**Preliminary Arborist Report
DRAFT**

To: JMK Homes c/o Jed Murphy
Site: 6610 E Mercer Way, Mercer Island, WA
Re: Tree inventory
Date: July 13th, 2022
Project Arborist: George White,
ISA Certified Arborist #PN-8908A
ISA Qualified Tree Risk Assessor
Reviewed By: Joseph Sutton-Holcomb
ISA Certified Arborist #PN-8397AM
Municipal Specialist, ISA Qualified Tree Risk Assessor
Referenced Documents: Topographic Survey (Pace Engineers, 6.6.2018)
Koneru Short Plat (Pace Engineers, Revised 4.12.2022)
Attached: Table of Trees
Tree Site Map

Figure 1. An excerpt from Composite Utility Plan C3.0 (7.20.2021) indicating the location of the new fire hydrant and water lines in relation to tree 573

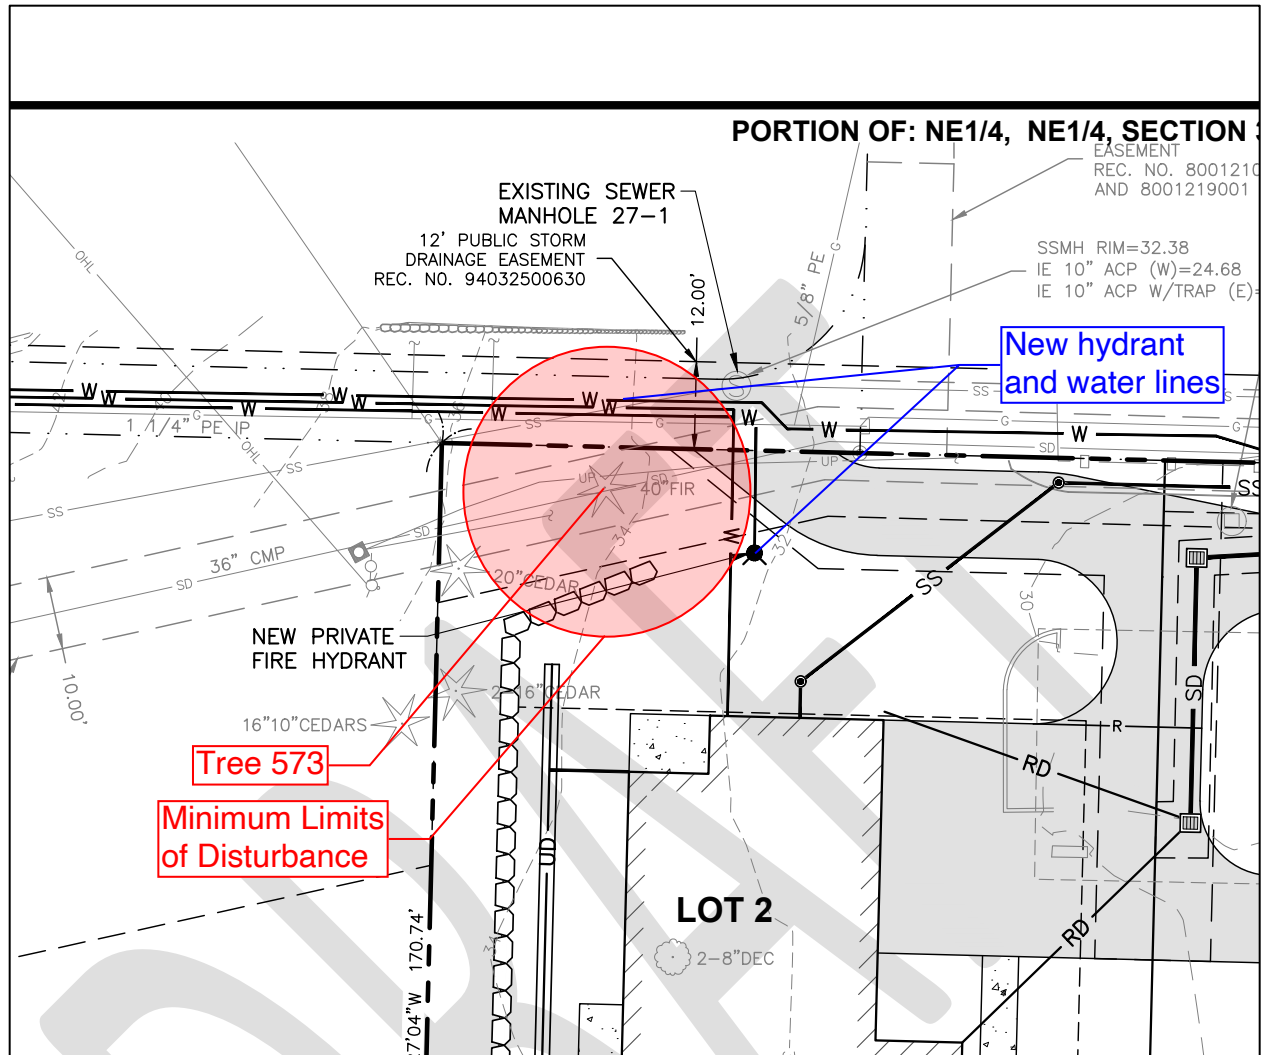
Tree 573 is an exceptional Douglas fir located in the middle of the existing driveway. This tree is currently proposed for removal because it conflicts with the installation of the required fire hydrant. Although the fire hydrant itself is outside of the MLOD, it is required to be hooked up to a new 6-inch water line which parallels the existing driveway. A 6-inch waterline will require a minimum 4-foot trench. There is no way to install this water line without routing it through the MLOD of tree 573 (See Figure 1).
